SEWAGE DISPOSAL SYSTEM

A REPAIR

PROPERTY OWNER Ralph Claggett
15878 Frederick Road

APPLICATION

Holes ① + ②
SOIL PROFILE

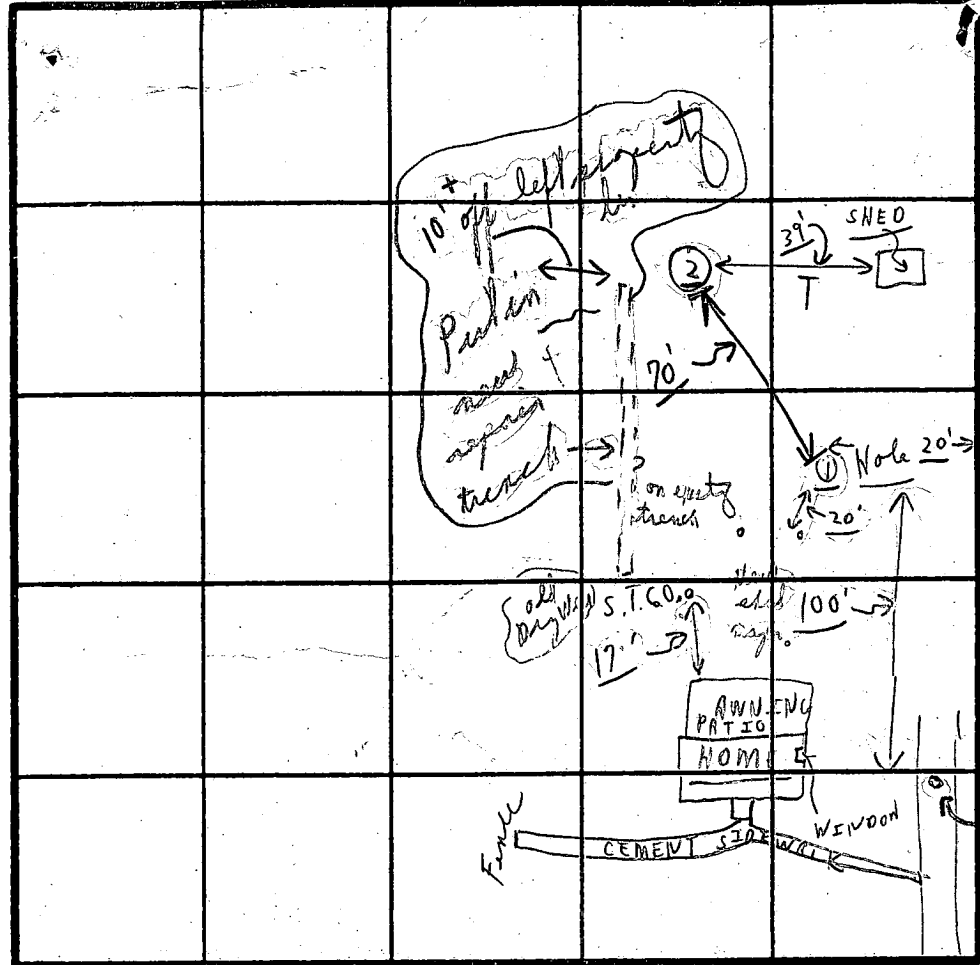
REASONS FOR REJECTION OR HOLDING 2/19/92 ① No one paid for this application yet. ② Hold for call on actual repair. ③ Keep trench 70' from water well.

220+ g pf / Bk. described
 OR capacity absorption
 ↓ trench 2' wide
 100' + long straight
 3' x 9'
 10' tall
 6' structure
 10' off left property

20' ± from well

Property of:
Ralph E. Claggett
15878 Fredrick Road
Woodbine, Maryland 21797
301-489-4704
Tax Map 7 Block 12
Parcel 189
Liber 425/Folio 339

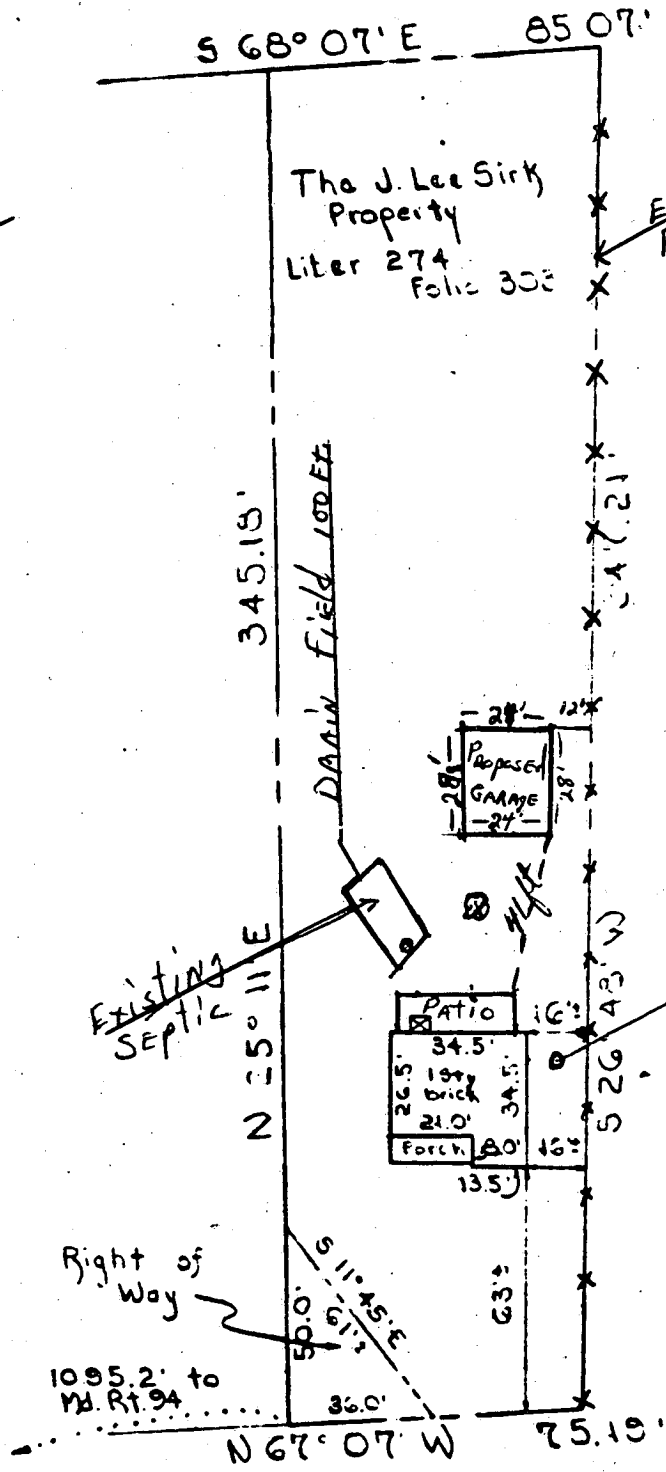
Note: GARAGE
To be 12 FEET off
of EXISTING FENCE

9/11/90
OK TO SIGN
RJ
Existing tree
